REGIONAL REVIEW FINDING

ARC REVIEW CODE: R507131

Submitting Local Government: City of Villa Rica
Name of Proposal: Panattoni Industrial Development

Preliminary Report:	July 13, 2005	DEVELOPMENT OF REGIONAL IMPACT REVIEW REPORT	Project:	Panattoni Industrial Park # 798
Final Report Due:	Aug 12, 2005		Comments Due By:	July 27, 2005

Limits of USACE Jurisdiction
Figure 2 of 2
Liberty Road/Villa Rica Tract
Carroll County, GA
for
Panattoni Development

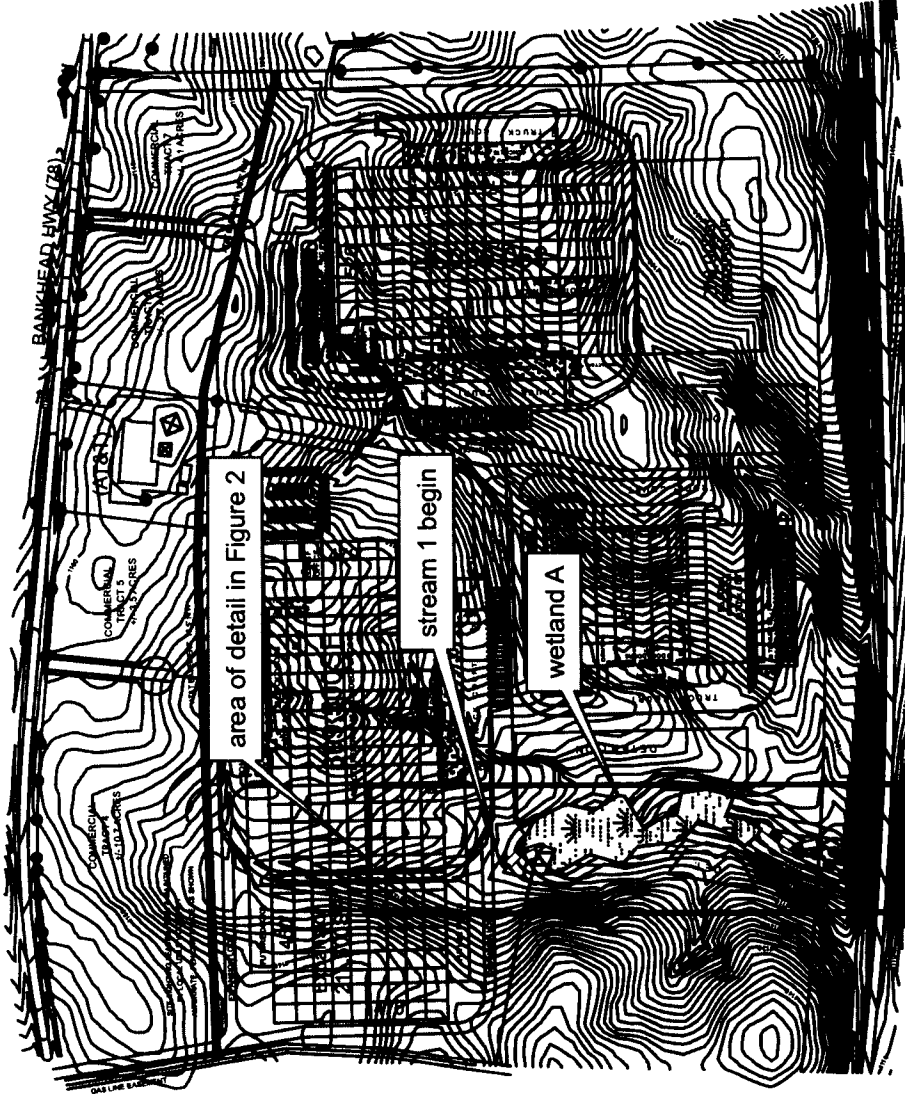
A portion of the intermittent stream shown on the USGS coverage for the site appears to be covered with buildings and impervious surface in this project design. All streams and any other waters of the State on the property must conform to the State 25-foot erosion and sedimentation buffer. Any work proposed within that buffer must conform to State erosion and sedimentation requirements and must be approved by the appropriate agency.

USGS Quad Map – Intermittent Stream: Per the jurisdictional water delineation performed by Register & Associates, our tract has only one stream and one wetland area within its 88 acres. Contrary to the location as shown on the USGS quad map, actual in-field delineation shows a stream along the southwest boundary of the site. In-field testing of the hydrological content of soils was utilized to pinpoint the limits of protected waters. The stream and associated buffers are correctly depicted on the attached survey. (the stream is slightly shorter than that which is shown on the DRI plan due to the execution of an in-field survey and inserting of GPS points associated with the stream limits.) (see survey.pdf) The attached

THIS PLAN IS A CONCEPTUAL REPRESENTATION
OF THE PROPOSED SITE DEVELOPMENT.
FINAL LAYOUT CONTINGENT UPON BOUNDARY
/ TOPO SURVEY AND JURISDICTIONAL PERMITTING.

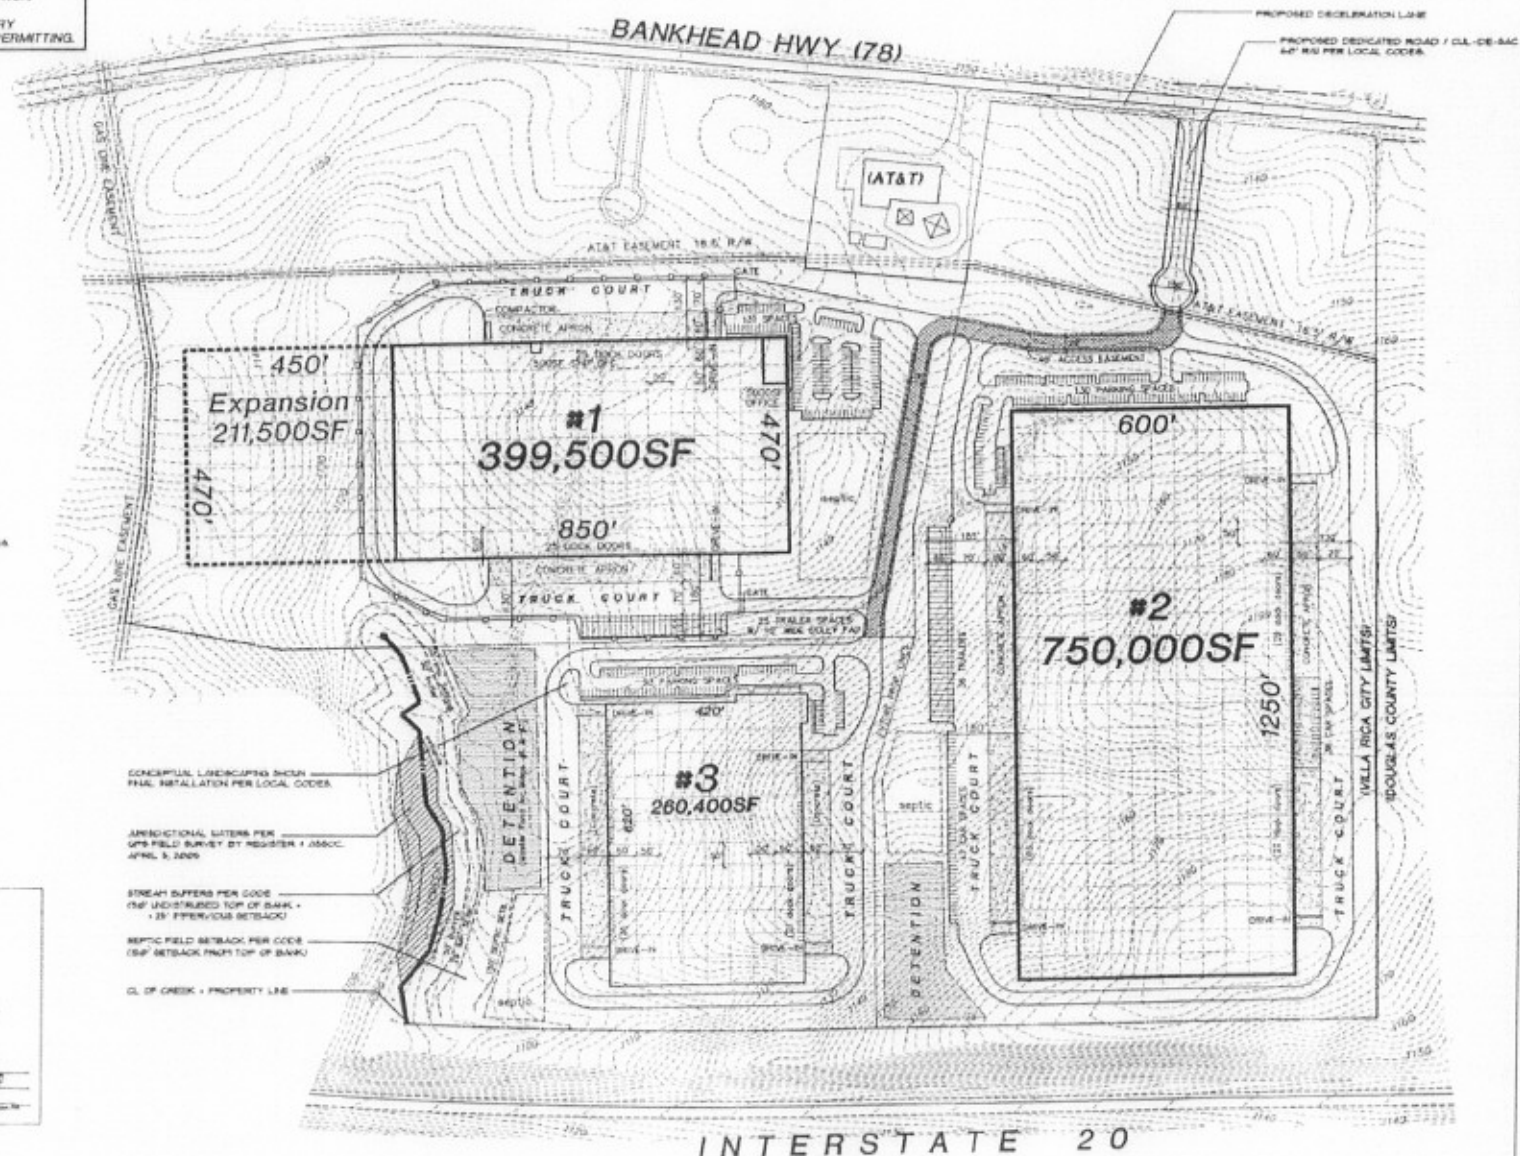
The Watershed Protection District has a limit of 25 percent impervious surface area for the entire water supply watershed area in the City. Site plan information provided on the submitted concept plan shows an estimated footprint coverage of 42.3 percent and an additional impervious cover area (assumed to be drives, parking and loading areas) of 22.4 percent, for a total of 64.7 percent impervious. To meet the Watershed District requirements, the project needs to meet the impervious surface limits on site or the City of Villa Rica must show how the proposed impervious area over 25 percent is permanently offset elsewhere in the City's portion of the watershed. ARC recently adopted a policy regarding impervious surface limits in small water supply watersheds. The policy resolution is attached at the end of this report. The City of Villa Rica has determined that the impervious surface areas located with the Dog River Watershed area are less than 25%. The corresponding letter is attached at the end of this report.

Refinement of the site plan is recommended to maintain and improve the environmental integrity of the surrounding area. Clear cutting of the vegetation should be minimized where possible. It is recommended that appropriate measures are taken to ensure the protection of the stream on the western portion site.

The Watershed Protection District also has a limit of 25 percent impervious surface area for the entire water supply watershed area in the City. Site plan information provided on the submitted concept plan shows an estimated footprint coverage of 42.3 percent and an additional impervious cover area (assumed to be drives, parking and loading areas) of 22.4 percent, for a total of 64.7 percent impervious. To meet the Watershed District requirements, the project needs to meet the impervious surface limits on site or show how the proposed impervious area over 25 percent is permanently offset elsewhere in the City of Villa Rica's portion of the watershed.

Car Pool/Parking Management/Mass Transit: The proposed site plan has been revised to show 5% of the parking spaces reserved for carpool vehicles. Spaces will be designated as such with a combination of pavement markings, curb-line markings and/or vertical signage. Plans submitted to Villa Rica, will be revised to reflect this inclusion of car pool spaces.
